**ADDENDUM No. 6**  
**STREET DEPARTMENT GARAGE FACILITY - 2024**

**City of Oregon**  
**Department of Public Service**

**M1.1**

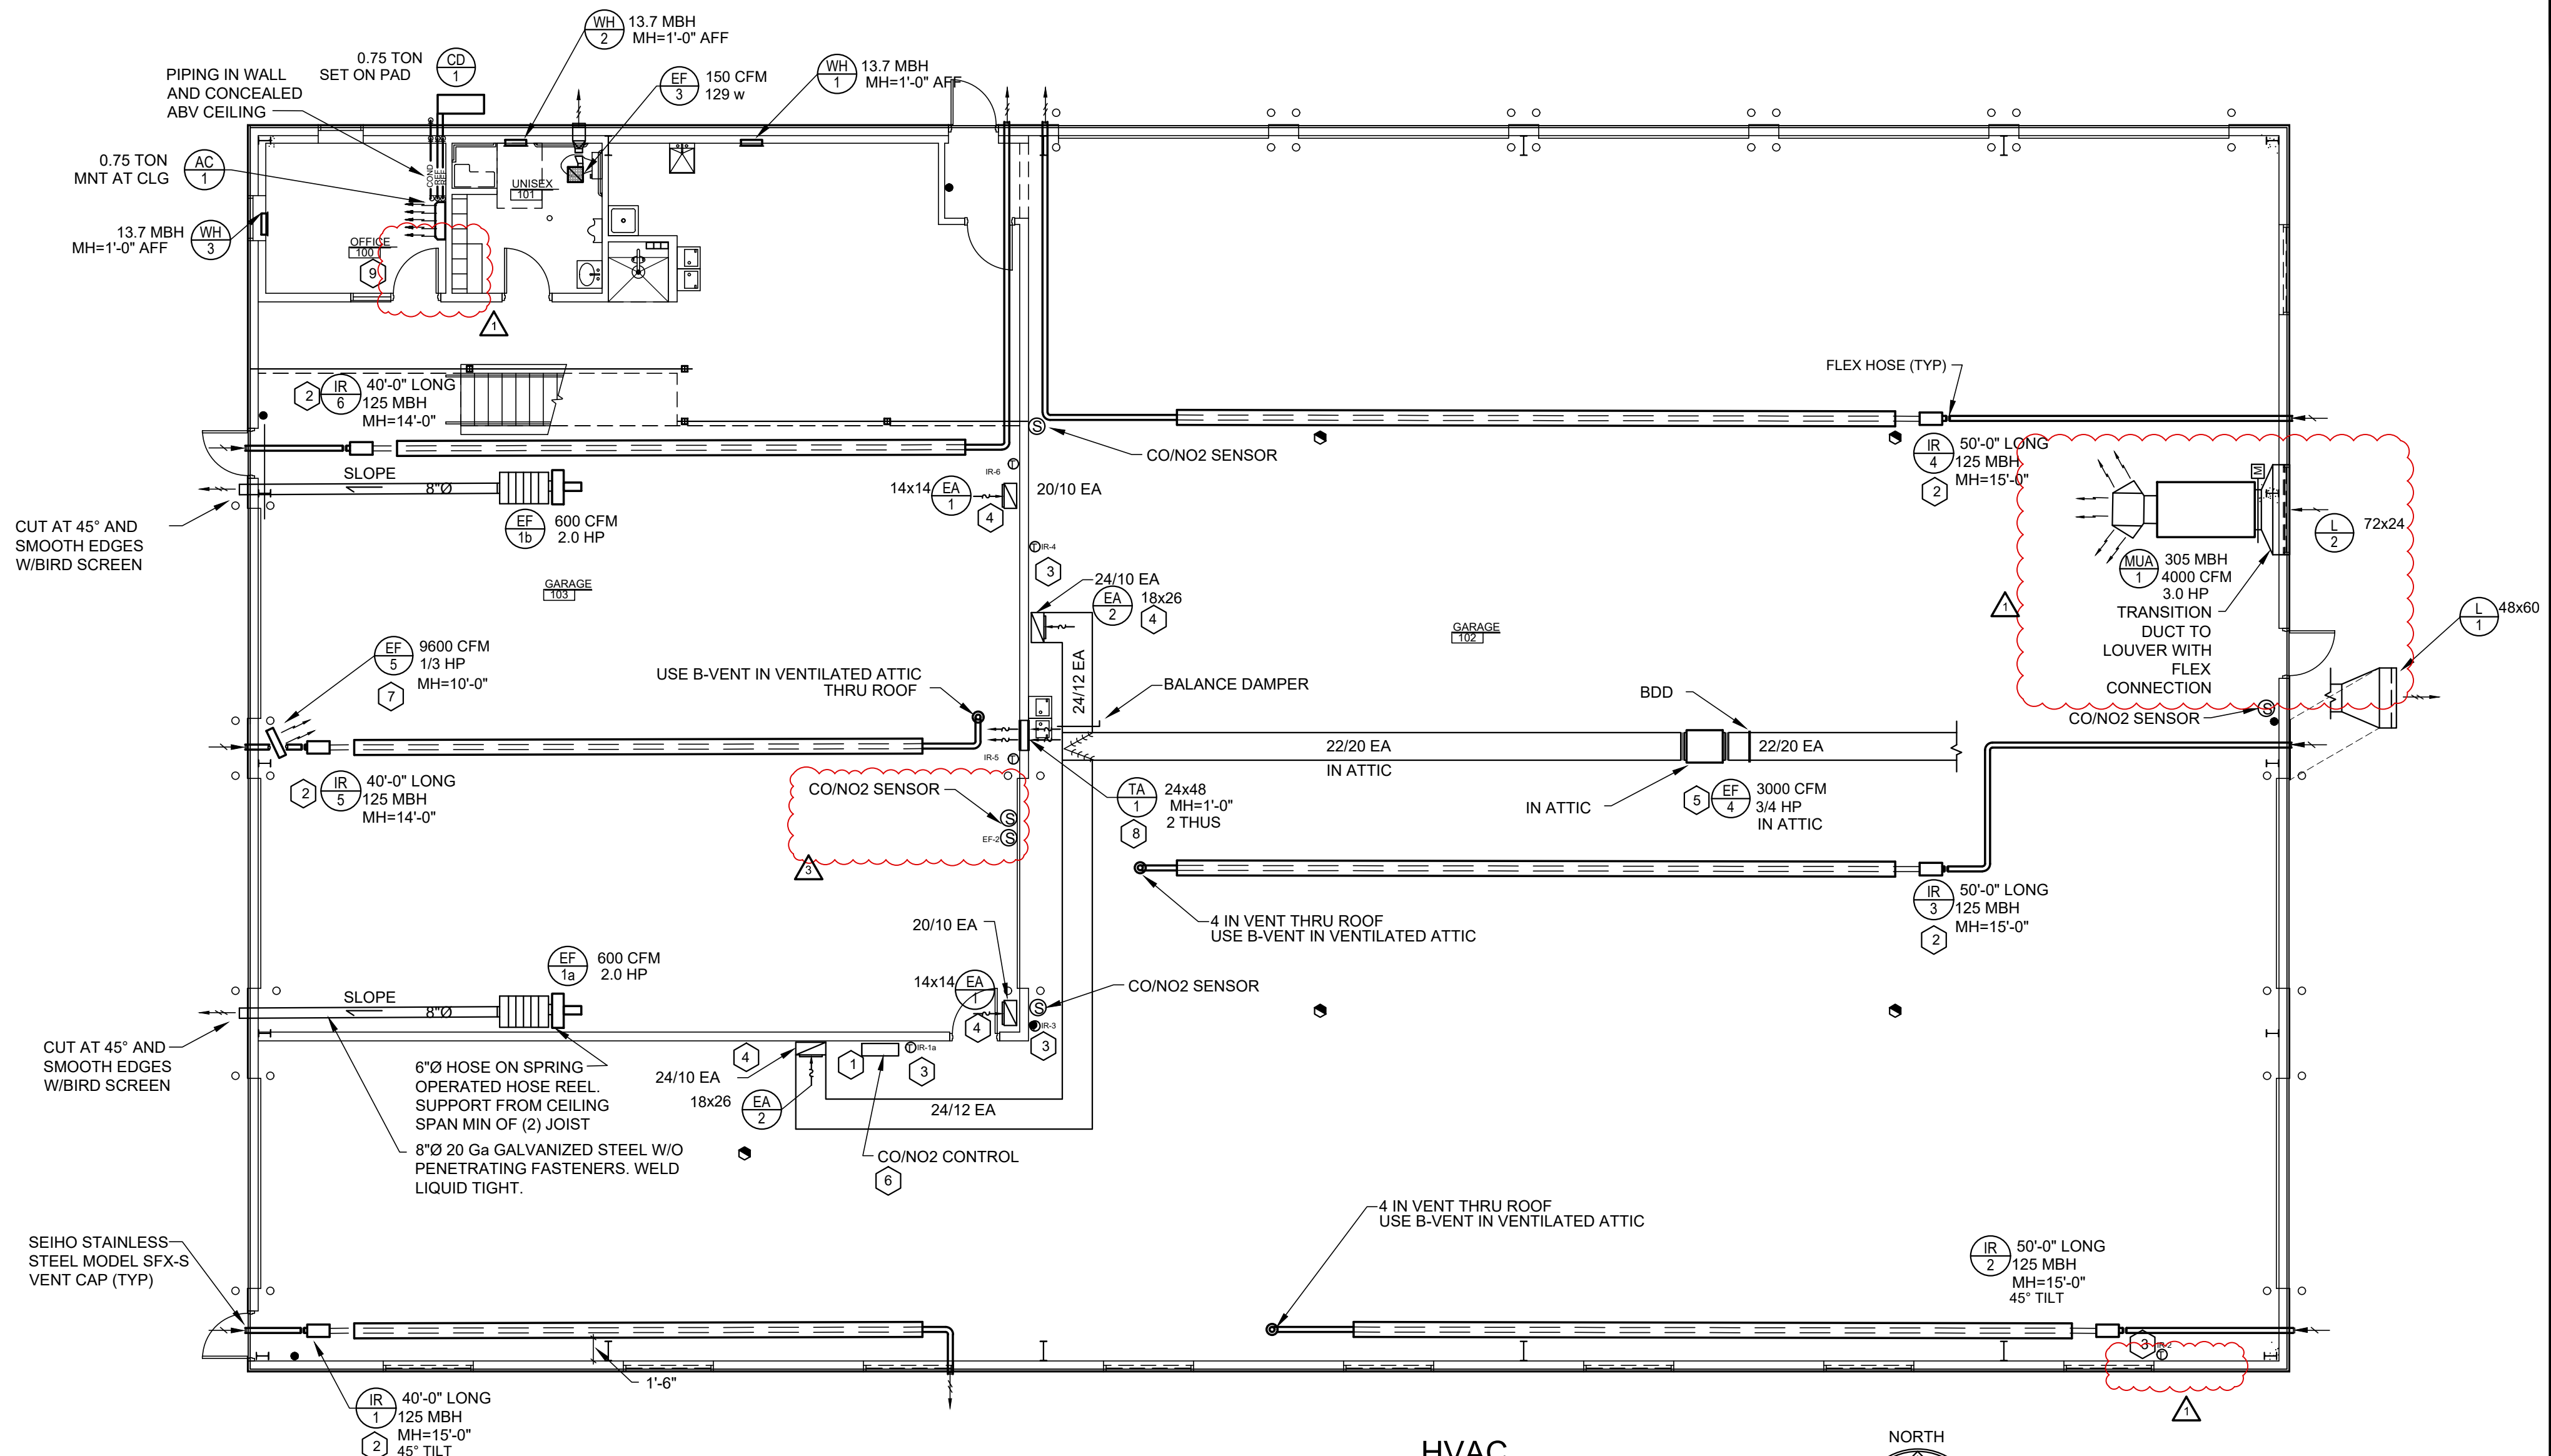
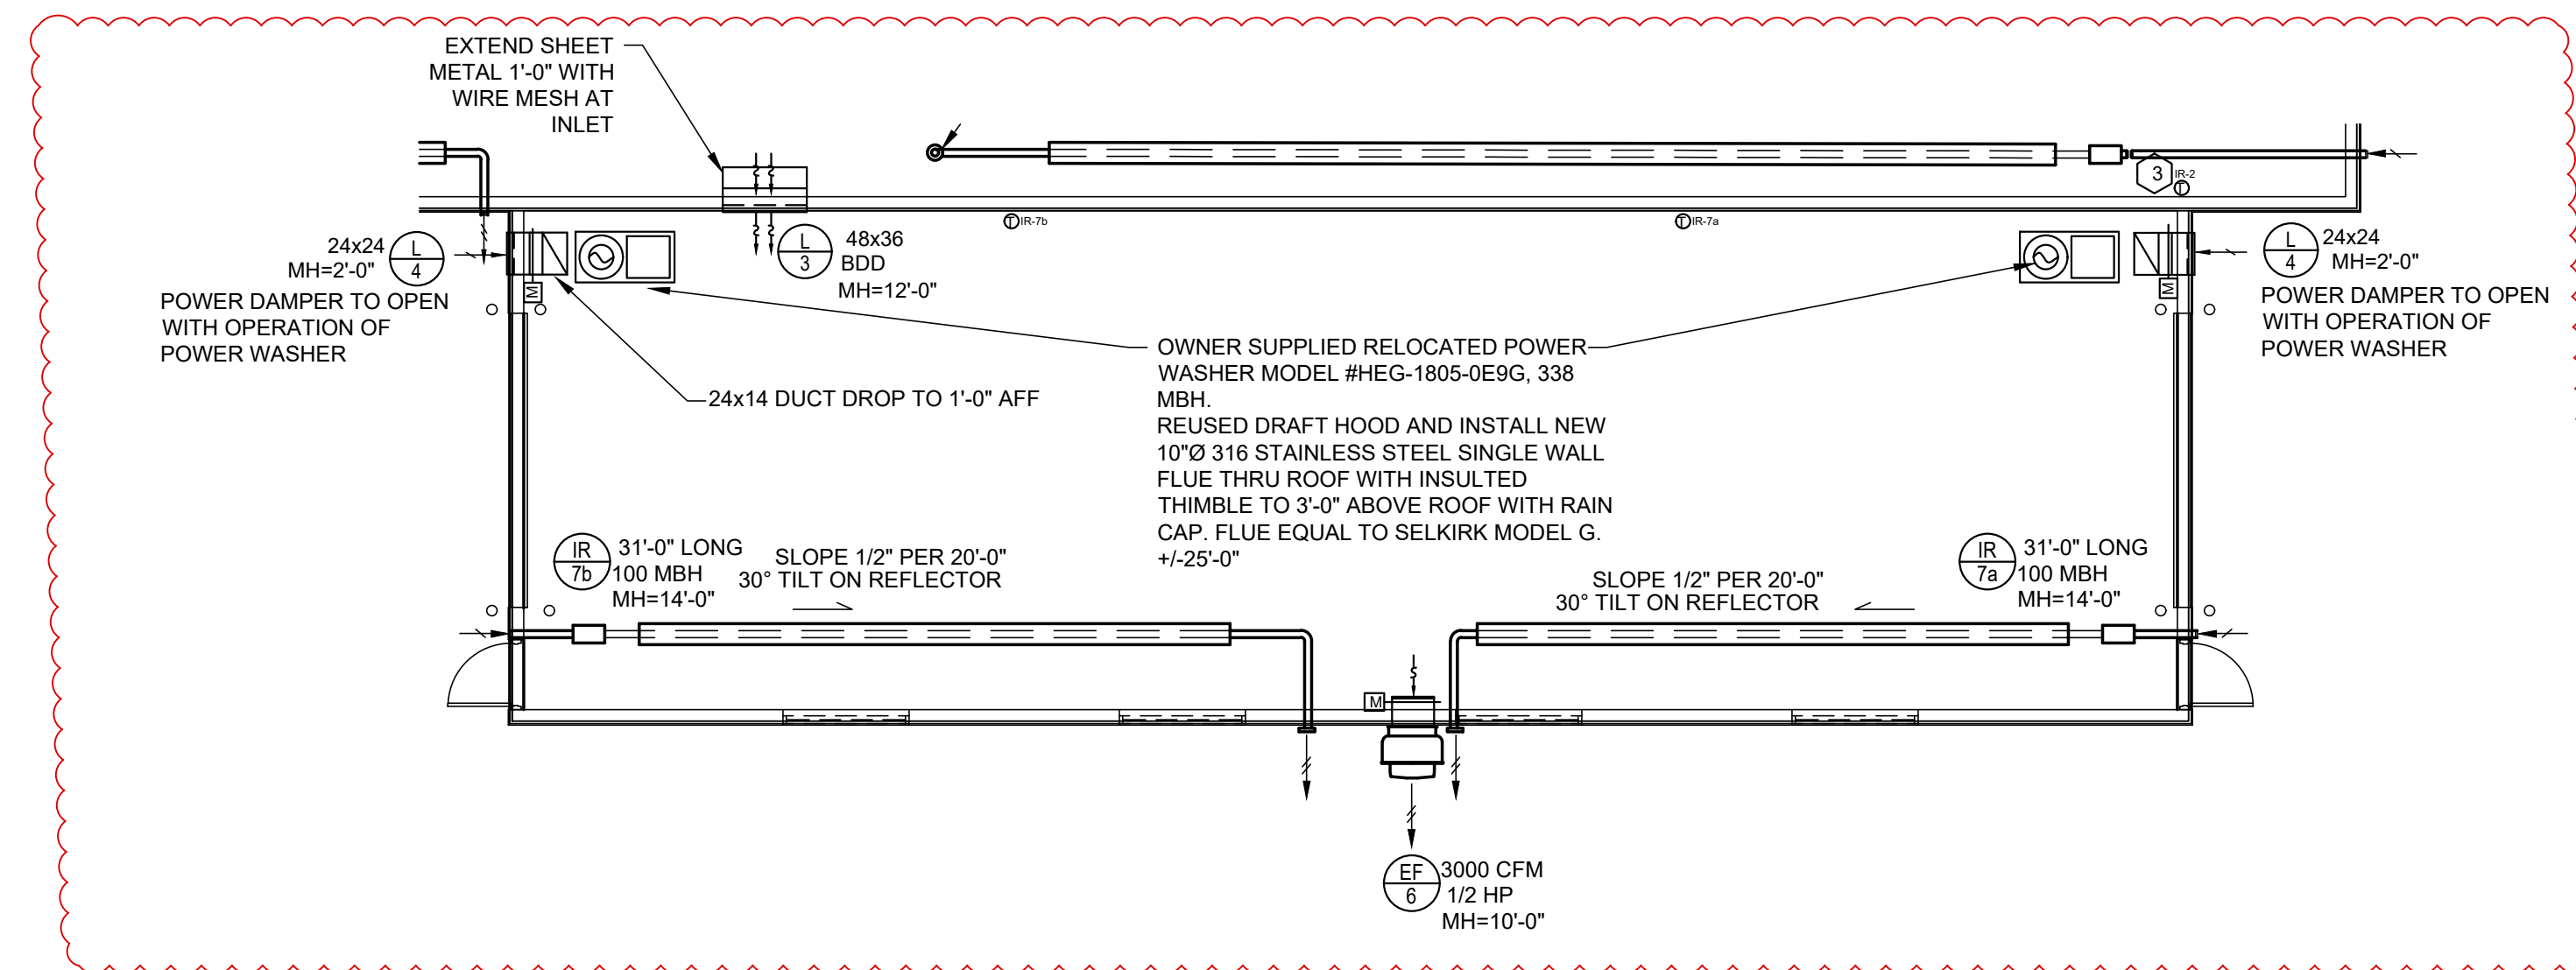
- 9) **Bidder Question:** *Can you guys provide a sequence of operations for the mechanical equipment and interlocking?*

**Architect/Engineer Response:** CO/NO2 sensor added in Garage 103. Per revised note #6 on drawing M1.1: COMBINATION MULTI POINT ARMSTRONG CO/NOx MONITOR SENSORS AT 5'-0" AFF. PROGRAM PACKAGED CO/NOX SYSTEM TO ENERGIZE EF-4, EF-2 AND MUA-1 ON ALARM. MUA-1 SHALL CONTROL ON UNIT INTERNAL CONTROLS PER SPECIFICATION SECTION 23 73 39. EXHAUST FAN SHALL HAVE THE CAPABILITY TO OPERATE MANUALLY. See revised drawing M1.1.

- 5 FASTEN EXH FAN ON SUPPORT SPANNING JOIST ON NEOPRENE ISOLATORS
- 6 COMBINATION MULTI POINT ARMSTRONG CO/NOx MONITOR SENSORS AT 5'-0" AFF. PROGRAM PACKAGED CO/NOx SYSTEM TO ENERGIZE EF-4, EF-2 AND MUA-1 ON ALARM. MUA-1 SHALL CONTROL ON UNIT INTERNAL CONTROLS PER SPECIFICATION SECTION 23 73 39. EXHAUST FAN SHALL HAVE THE CAPABILITY TO OPERATE MANUALLY.
